Randwick Local Planning Panel (Public) Meeting

Development Application Report No. D1/22

Subject: 2 Barrett Place Randwick (DA/409/2019/B)

Proposal:	Section 4.55(2) modification of approved development to modify the garage, fencing and first floor bathroom. Original Consent: Alterations and additions to the existing semi-detached dwelling including new first floor addition, garage to side and boundary fence, associated site and landscaped works.
Ward:	North Ward
Applicant:	Ms K L Burke
Owner:	Mr W J Binsted & Ms K L Burke
Cost of works:	\$318,500
Reason for referral:	10 unique submissions by way of objection were received

Figure 3. Modified terrace plan – 2 Barrett Place, Randwick

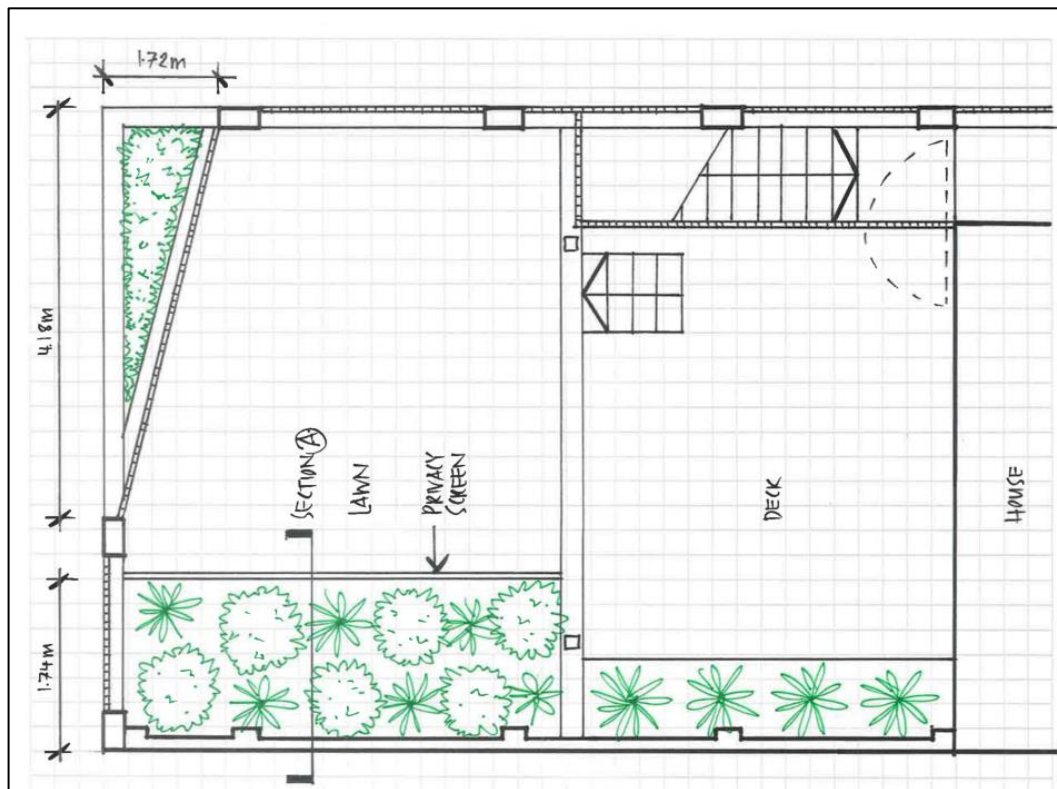
- Finished floor level of garage raised by 100mm to RL 68.42 to meet DA condition 9 (footpath levels)
- Finished level of garage roof slab raised by 240mm to RL70.93 as a result of item 1 above and to achieve compliance with Condition 12 (BCA compliance for the garage door opening height)
- Garage width increased to 3.5m internally to provide side room for garage door installation and to allow bicycle storage in the garage
- Balustrading on garage roof terrace to a height of RL72.15 to create a 1m high barrier protection above the lawn level.
- New privacy screen along the southern side of the garage roof terrace with a minimum height of 1600mm above the lawn area, to prevent sightlines to the deck area and rear facing windows at the ground.

- b. The proposed 'L' shape privacy screen located towards south-eastern corner of the garage roof terrace as shown on drawing No. DA-500 (Issue C) shall be deleted.
- c. The two pillars located on the western boundary, closest to the northern boundary, shall be demolished. Balustrading on the western boundary, within 4.18m of the northern boundary, and balustrading on the northern boundary, within 1.72m of the western boundary shall also be demolished.

Figure 13. Drawing SK-001 – 2 Barrett Place, Randwick (Source: K Burke, 26/10/2021)

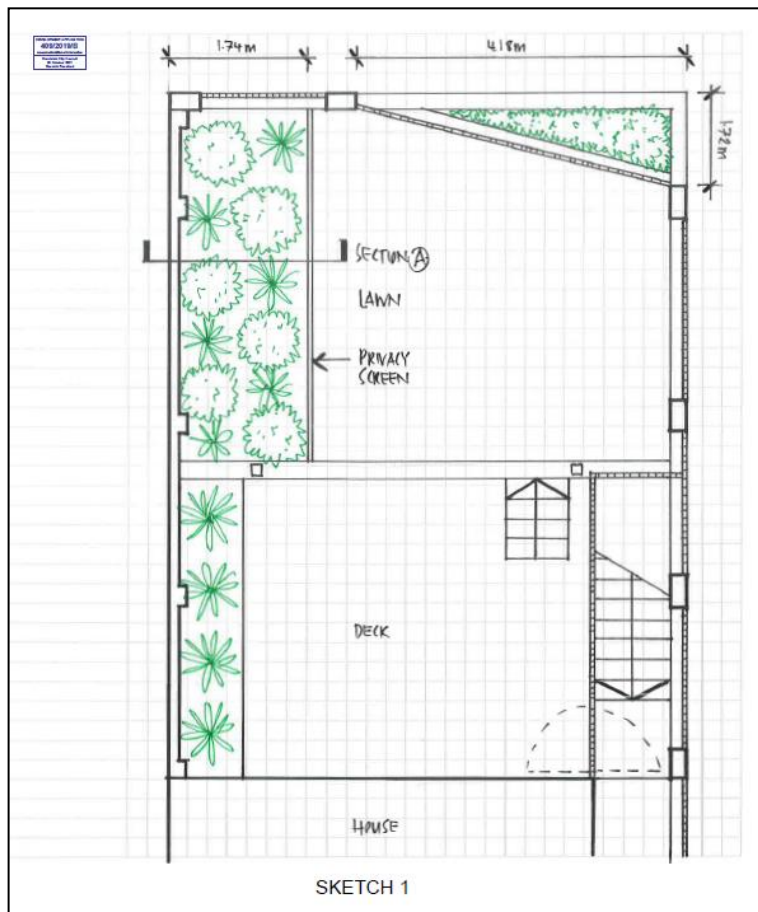
Following discussions between Council and the adjoining neighbours, as well as discussions between Council and the applicant – the proposed modification application is acceptable with the following amendments, as illustrated in the sketches in Figures 13 & 14.

- A full length 1.6m high privacy screen shall be provided parallel to, and setback 1.74m from, the boundary of 4 Barrett Place. The 1.74m setback figure is derived from calculation of the sun angle, to ensure that the 1.6m high privacy screen does not create additional overshadowing impact on 4 Barrett Place. The setback also mitigates the bulk impact of the privacy screen. The privacy screen will be open beneath the height of 1m (consistent with the minimum height of the boundary wall above terrace FFL), to enable access into the setback for the maintenance of planting.

- The approved southern boundary wall was scaled off the DA/409/2019 plans by Council's Compliance team to have a height of RL 72.15. The identification survey prepared by G.K. Wilson & Associates, dated 6/08/2020, identifies the as-built height of the southern boundary wall to be RL 72.15, consistent with the approval. This wall is commensurate in height with the previous fencing on this boundary. The impact of the approved boundary wall is thus considered acceptable in the context of previous development, and shall be retained to maintain safety, as the privacy screen allows access into the setback.

- A corner splay shall be provided to the balustrading on the north-western corner of the roof terrace, requiring the demolition of the corner pillar and the second pillar from the street on the western boundary. A new balustrade shall be installed between the existing pillar on the western boundary, which is setback 4.18m from the street boundary, and the existing pillar on the street boundary, which is setback 1.72m from the western boundary. The setback arising from the corner splay will minimise the bulk impact on the streetscape and 54 Gilderthorpe Avenue, as well as mitigate overlooking into the windows of 54 Gilderthorpe Avenue.

- a. A privacy screen shall be provided parallel to the southern boundary, between the western and eastern edges of the garage roof terrace.

The privacy screen shall have a minimum setback of 1.74m from the southern boundary as shown on drawing No. SK-001 (Rev A).

The privacy screen shall have a height of 1.6m above terrace finished floor level – i.e. the privacy screen shall have a height of RL 72.73. The privacy screen may be open beneath a height of 1m above FFL (RL 72.13) to enable access into the setback for the maintenance of planting only.

A new balustrade shall be installed between the existing pillar on the western boundary, which is setback 4.18m from the street boundary, and the existing pillar on the street boundary, which is setback 1.72m from the western boundary, forming a corner splay as shown on drawing No. SK-001 (Rev A). The balustrade shall have a height of RL 72.15.
